TO : All Bidders
FROM : Bob Lavey
PROJECT : Nogales High School Interim Locker and Restroom Portables
Project 230384.41
SUBJECT : Addendum 2
DSA : 04-123338 / File 33-13

ADDENDUM NO. 2

DRINKING FOUNTAIN - EXISTING CONDITIONS

CMSK - 4

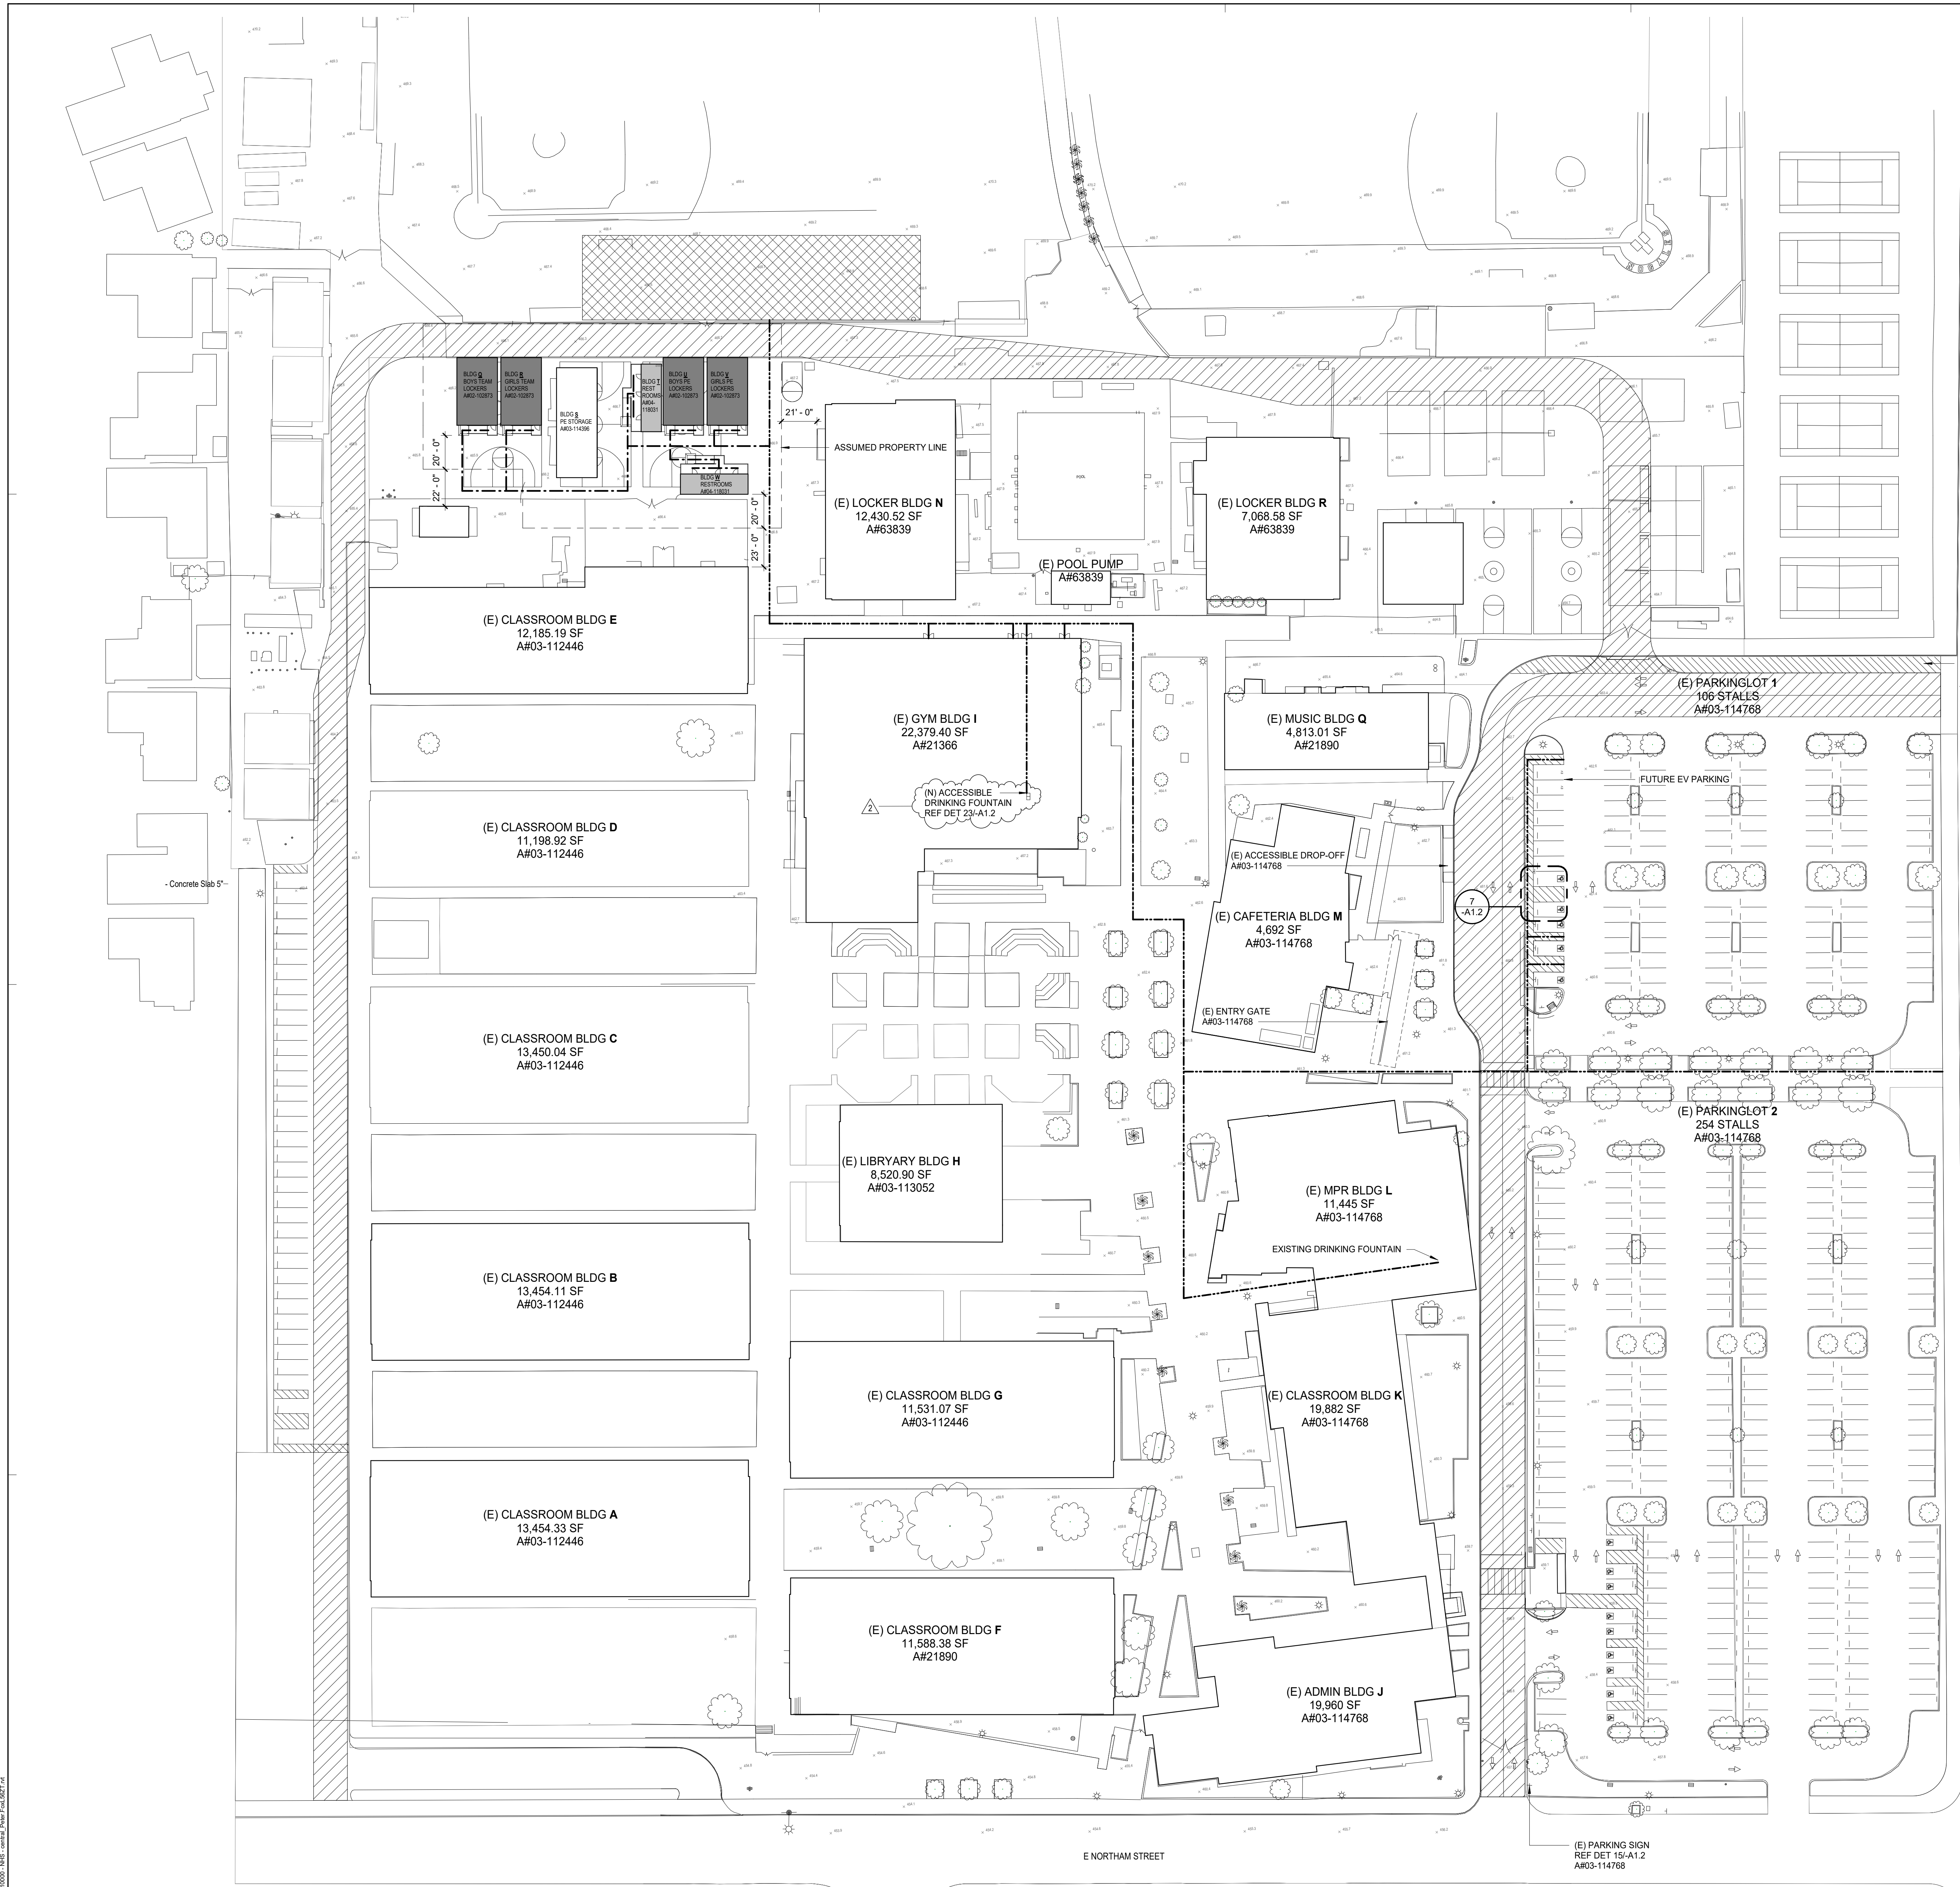
2.2 Add in its entirety CMSK-4 with the attached.

1 - GENERAL CONTRACTOR SHALL CAREFULLY DISCONNECT, REMOVE AND TURN OVER TO DISTRICT THE EXISTING BOTTLE FILLER.

2 - GENERAL CONTRACTOR SHALL CUT AND PATCH EXISTING CERAMIC TILE, DRYWALL INCLUDING PAINT, AND FLOORING AS REQUIRED TO INSTALL NEW WORK. PATCHING SHALL MATCH EXISTING CONSTRUCTION AND FINISH.

3- GENERAL CONTRACTOR DEMOLISH THE EXISTING HAND RAILS AND PATCH FLOOR TO MATCH EXISTING CONSTRUCTION AND FINISH.

4- GENERAL CONTRACTOR SHALL INTERCEPT, RE-ROUT AND EXTEND EXISTING PLUMBING AS REQUIRED TO MAKE FINAL CONNECTIONS TO THE NEW HIGH LOW DRINKING FOUNTAIN. THIS SHALL INCLUDE INSTALLING WATER FILTER MODEL 6426, 10"x 2" IN-LINE LEAD REMOVAL ELEMENT.

5 - GENERAL CONTRACTOR SHALL INTERCEPT, RE-ROUT AND EXTEND THE EXITING ELECTRICAL AND MAKE FINAL CONNECTION TO NEW HIGH LOW DRINKING FOUNTAIN.

6 - GENERAL CONTRACTOR SHALL DEMOLISH EXISTING WALL MOUNTED DISPLAY CASE INCLUDING PATCH AND PAINT THE AREA TO MATCH ADJACENT WALL FINISH AND CONSTRUCTION.

7 - GENERAL CONTRACTOR SHALL PROVIDE ALL ROUGH FRAMING AND BLOCKING REQUIRED FOR THE INSTALLATION OF THE NEW DRINKING FOUNTAIN.

DRAWING NUMBER: **-A1.1**

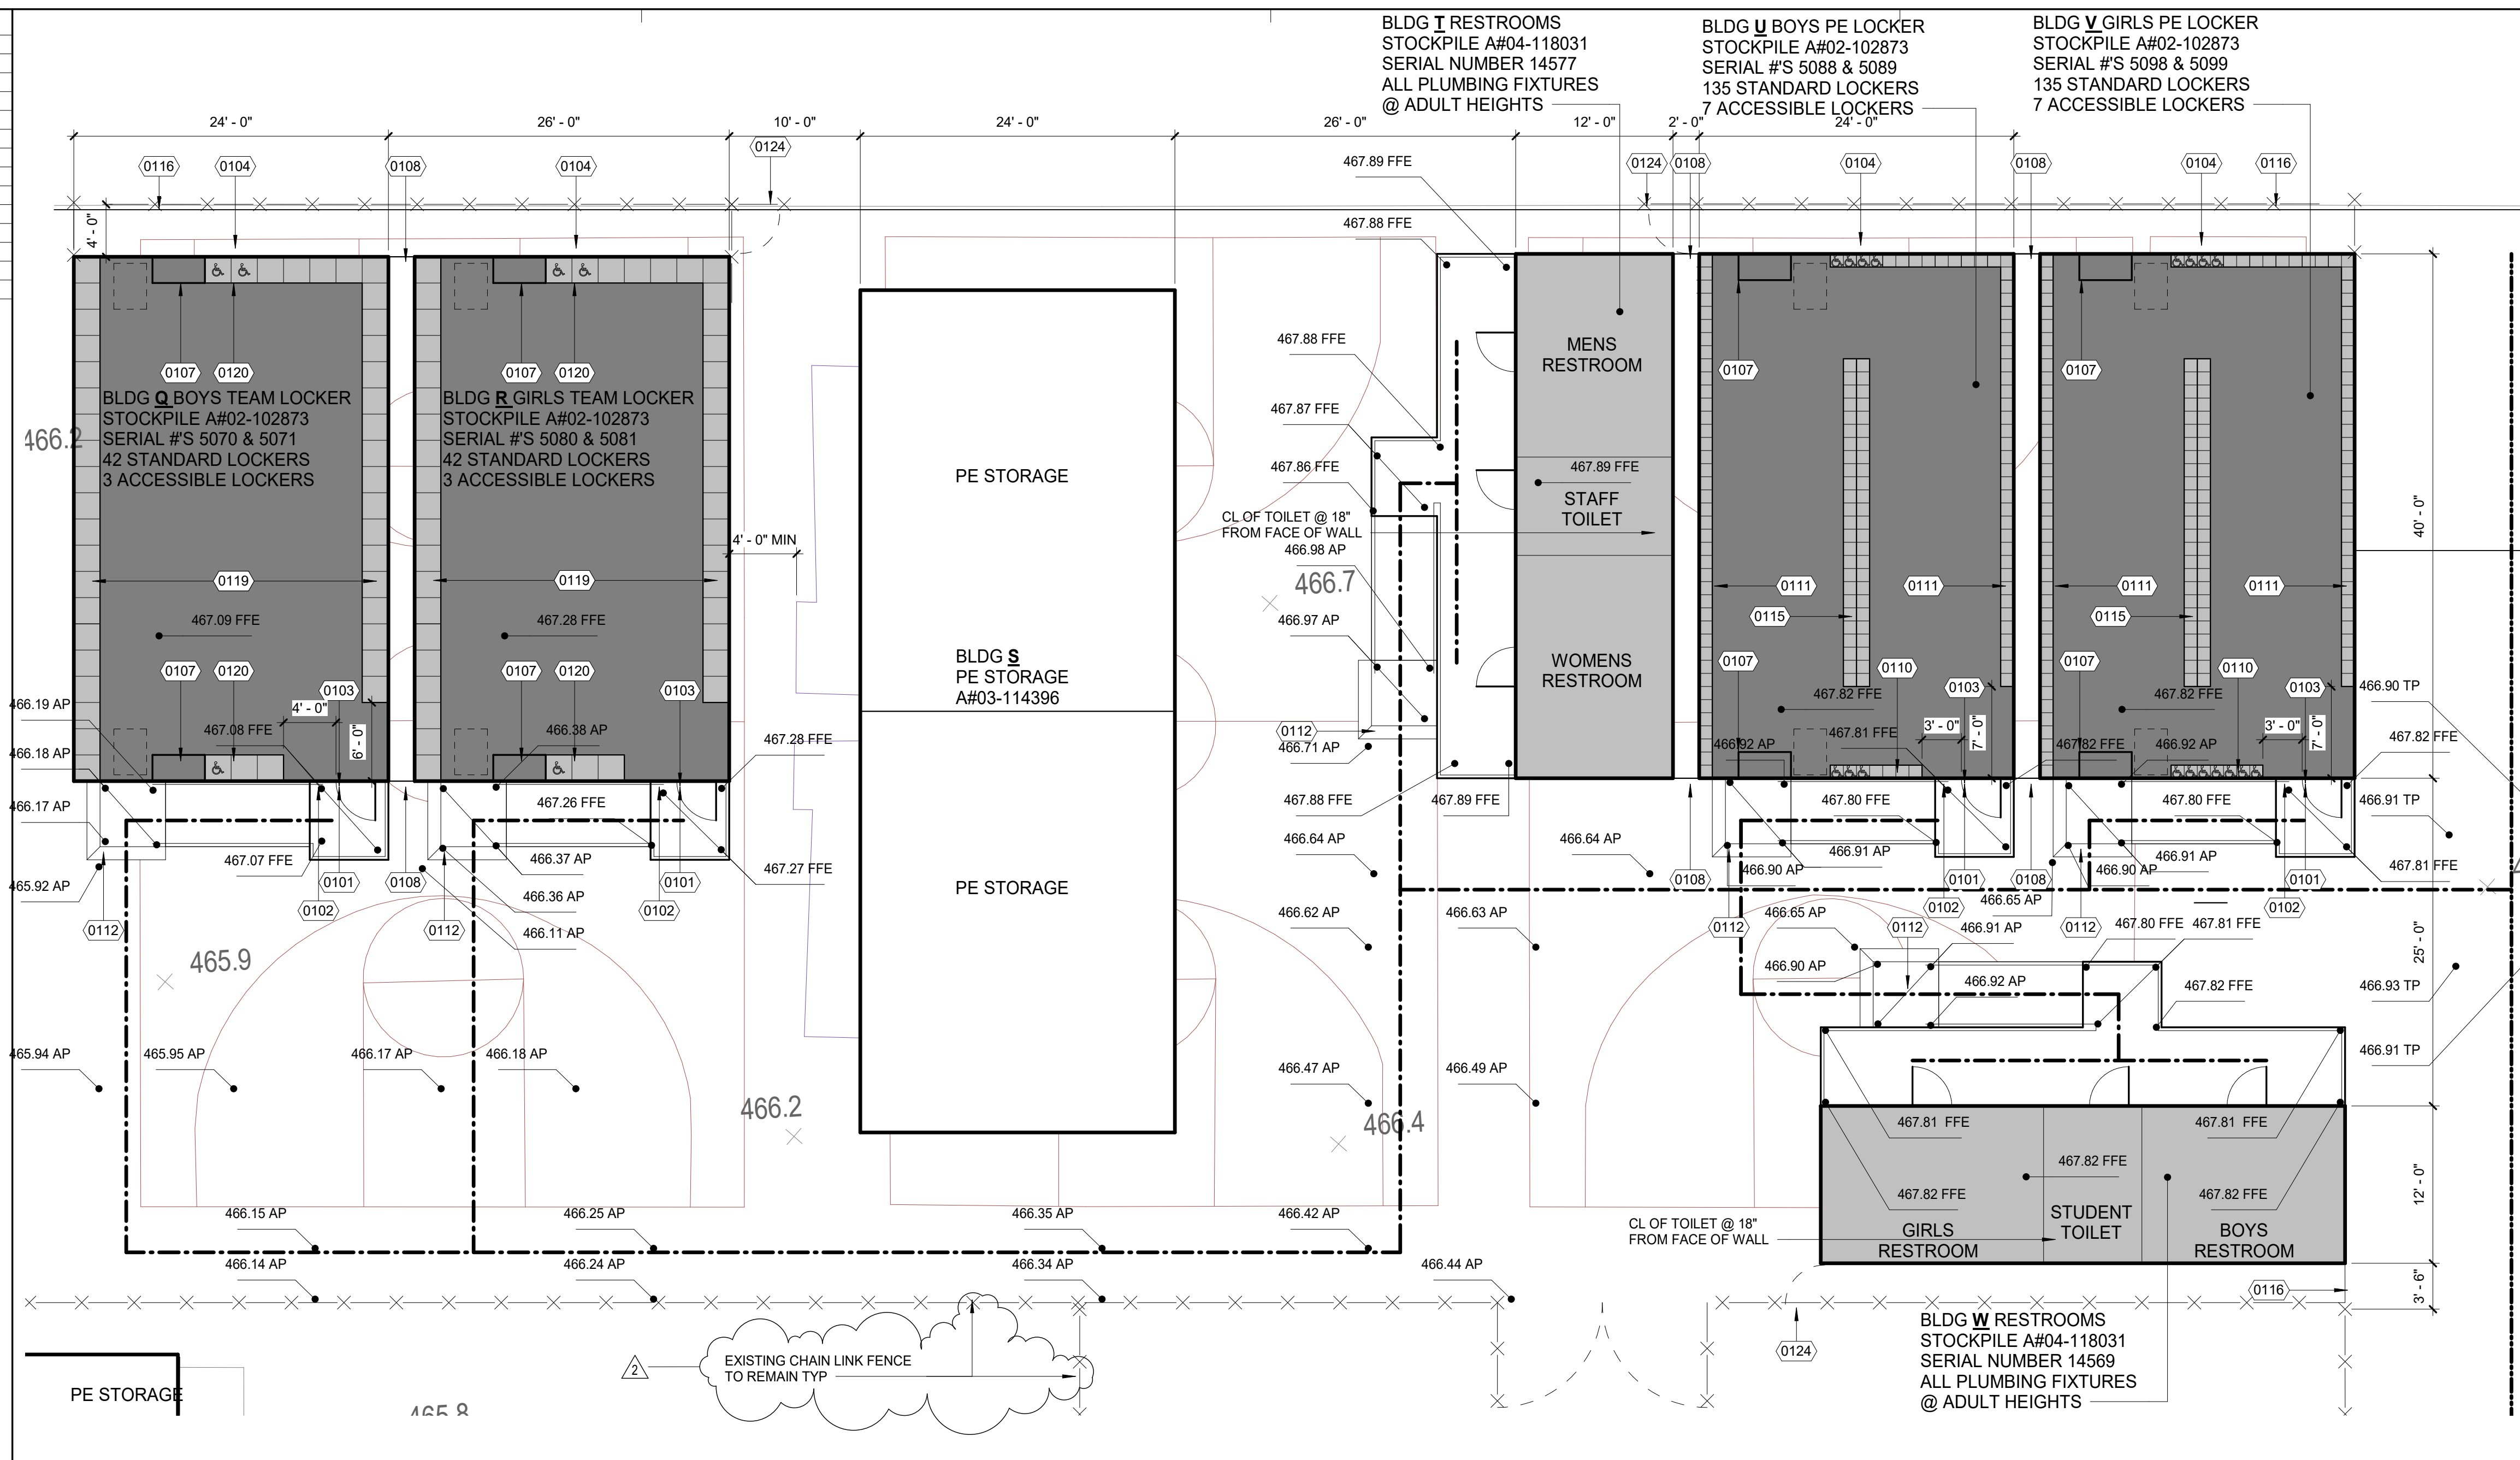
- A. Relocated the new drinking fountain per the attached Drawing A1.1.
